### **Proposal for a new UN Regulation on the approval of devices for reversing motion and motor vehicles with regard to the driver's awareness of vulnerable road users behind vehicles**

**Submitted by the Informal Working Group on Awareness of Vulnerable Road Users Proximity\***

**OICA Comment: Green**

**Japan Comment: Purple**

## Utilization of tractor-units as solo vehicles

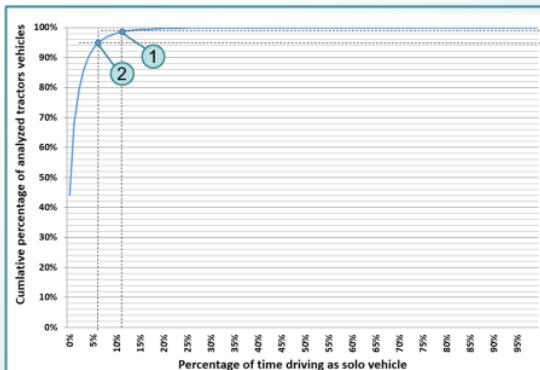
**- Vehicles intended to be used with a semi-trailor shall be exempted from this Regulation.**

**OICA Justification:** already discussed in the previous IWG meeting with CP

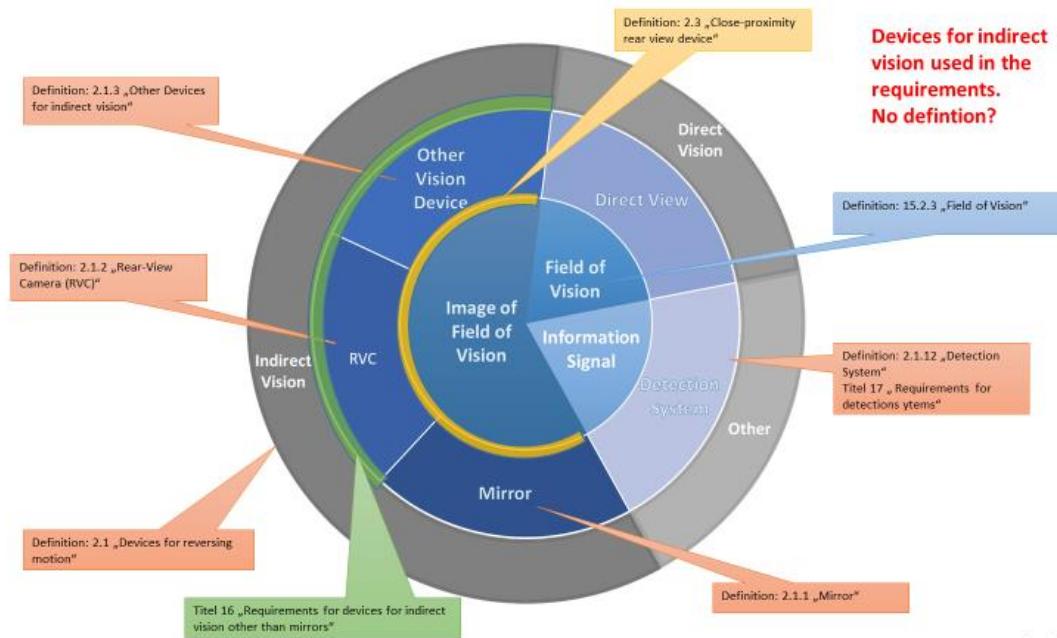
Comment: Do we all have the same understanding of the definitions?

- Devices for reversing motion:
  - Include Indirect vision + direct vision + Other (grey ring)
    - If yes, we shall modify the definition
    - If no, what is a device for reversing motion?
  - Include Indirect vision only?
    - If yes, it is equivalent to the definition “close proximity rear view device”

- We propose to replace Camera-Monitor System (CMS) by Rear-View Camera (RVC) to avoid misunderstanding between UN-R46 and this regulation

Japan Comment: It is Indirect Vision only.

Japan Comment: Agreed. All description of CMS was replaced to RVC.

Japan Comment: This figure is matching intention of devices for this regulation.

Figure 2

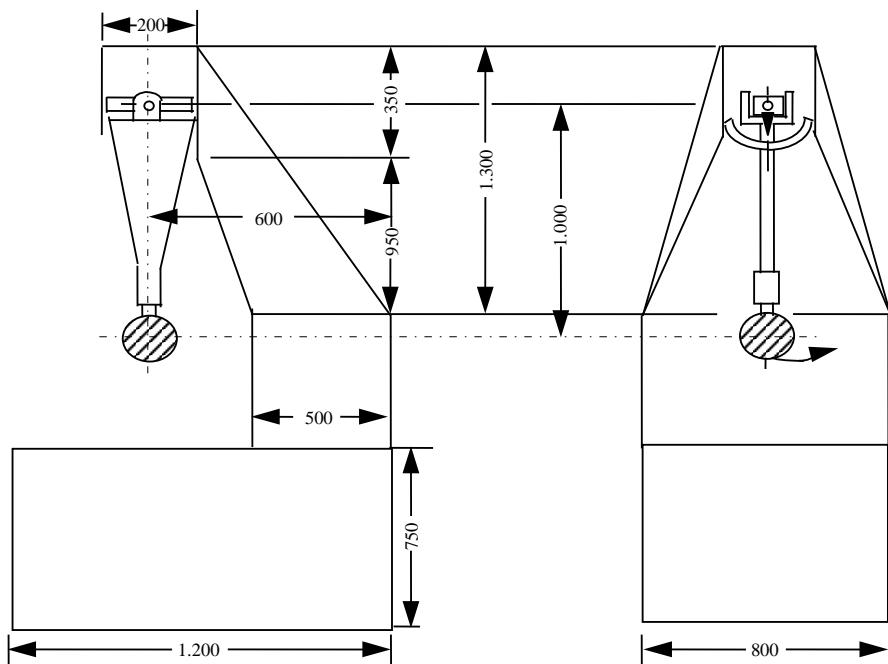
Japan Comment: Impact Test part (6.3) was agreed to be [ ] and ask CP's opinion in GRSG in last IWG.

OICA Comment: The complete section 6.3 is not clear. What needs to be tested? Outside component, inside component?

Japan Comment: To make it clear, 6.3.1 corrected.

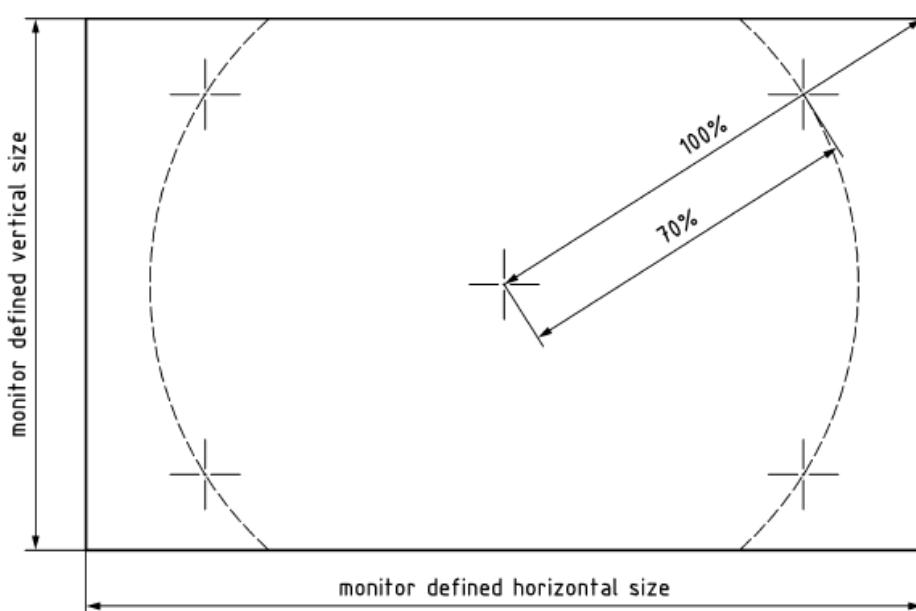
~~The resolution (MTF) defines the minimum distinguishable details observable in an image as is represented by the MTF10. For reasons of simplicity the requirement is defined assuming an aspect ratio of 1:1.~~

~~Resolution MTF10, at the centre of the monitor defined size shall fulfil the following requirements:~~

Japan Comment: To be removed, not fit rear-view camera that have fish-eye lens.
